ADDENDUM NUMBER 3

- 1.01 DATE: October 6, 2023**
- 1.02 PROJECT: ERNEST KNIGHT LLC FIRE ALARM SYSTEM**
- 1.03 PROJECT NUMBER: 26236.0 DCM/BC NO. 2023632**
- 1.04 OWNER: ALABAMA A&M UNIVERSITY**
- 1.05 ARCHITECT: HYDE ENGINEERING, INC.**

NEW FIRE ALARM SYSTEM FOR ERNEST KNIGHT LIVING AND LEARNING COMPLEX
ALABAMA A&M UNIVERSITY

DATE: 08/28/23
 JOB NUMBER: 26236.0
 DRAWN BY: BR
 CHECKED BY: MBR
 DRAWING TITLE: FIRST FLOOR PLAN - AREA A - FIRE ALARM
 DRAWING NO. E2.1

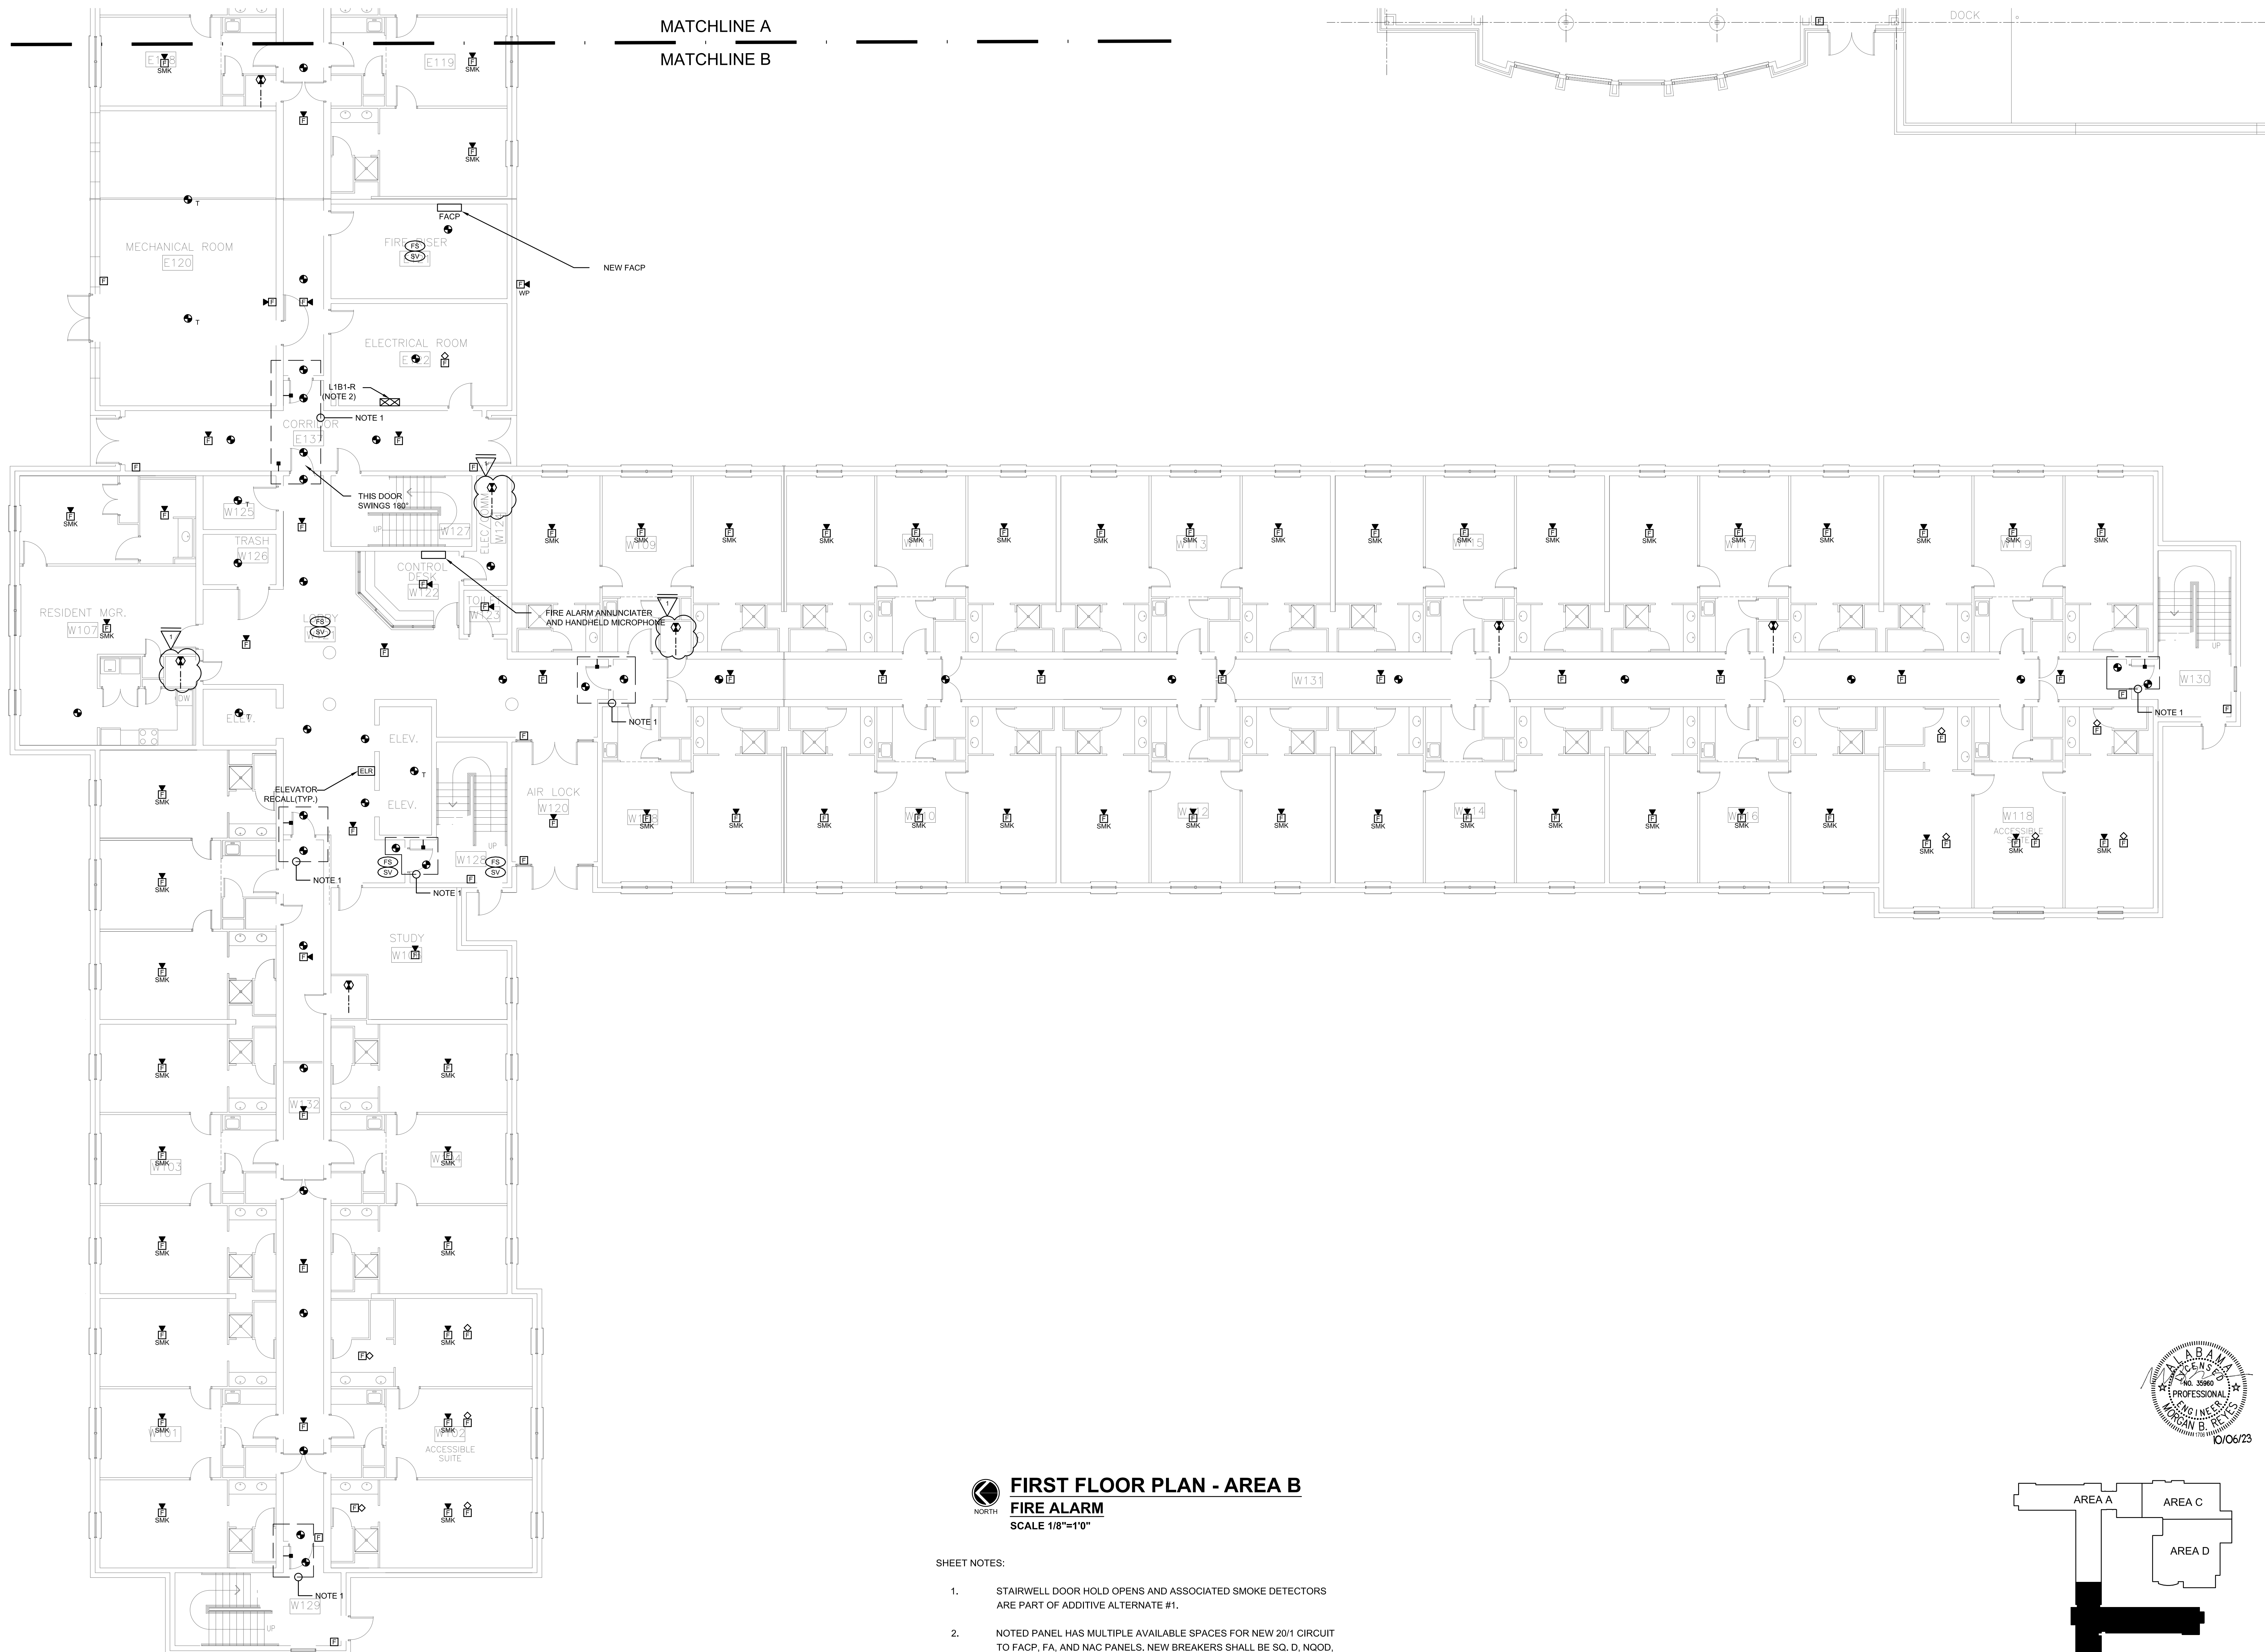
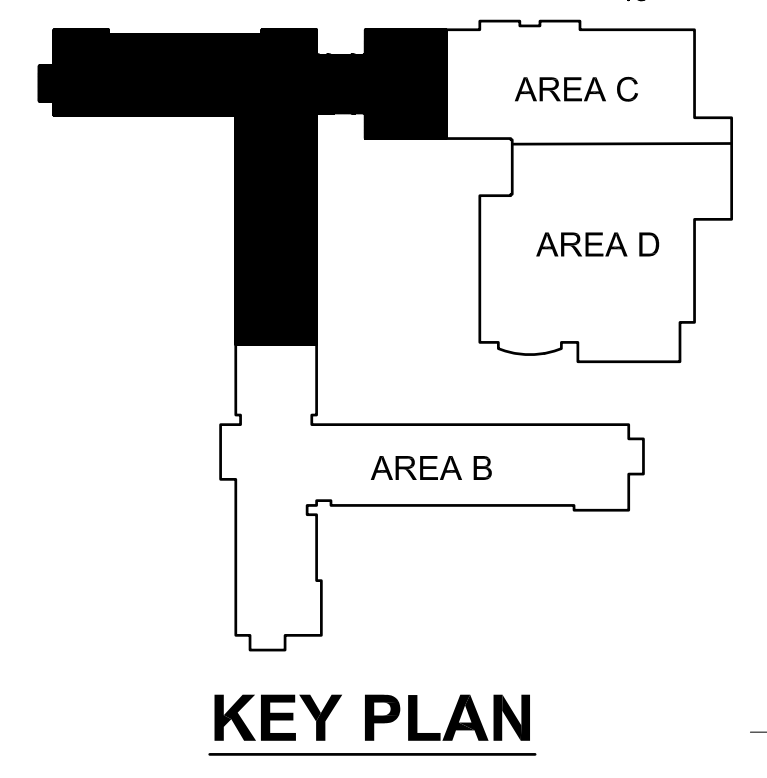
- 3.01 SHEET E2.1 – FIRST FLOOR PLAN – AREA A – FIRE ALARM**
A. Add duct detectors as shown.
- 3.02 SHEET E2.2 – FIRST FLOOR PLAN – AREA B – FIRE ALARM**
A. Add duct detectors as shown.
- 3.03 SHEET E2.3 – FIRST FLOOR PLAN – AREA C – FIRE ALARM**
A. Add duct detectors as shown.
- 3.04 SHEET E3.1 – SECOND FLOOR PLAN – AREA A – FIRE ALARM**
A. Add duct detectors as shown.
- 3.05 SHEET E3.2 – SECOND FLOOR PLAN – AREA B – FIRE ALARM**
A. Add duct detectors as shown.
- 3.06 SHEET E4.1 – THIRD, FOURTH, AND FIFTH FLOOR PLAN – AREA A – FIRE ALARM**
A. Add duct detectors as shown. Typical of each floor.
- 3.07 SHEET E4.2 – THIRD, FOURTH, AND FIFTH FLOOR PLAN – AREA B – FIRE ALARM**
A. Add duct detectors as shown. Typical of each floor.
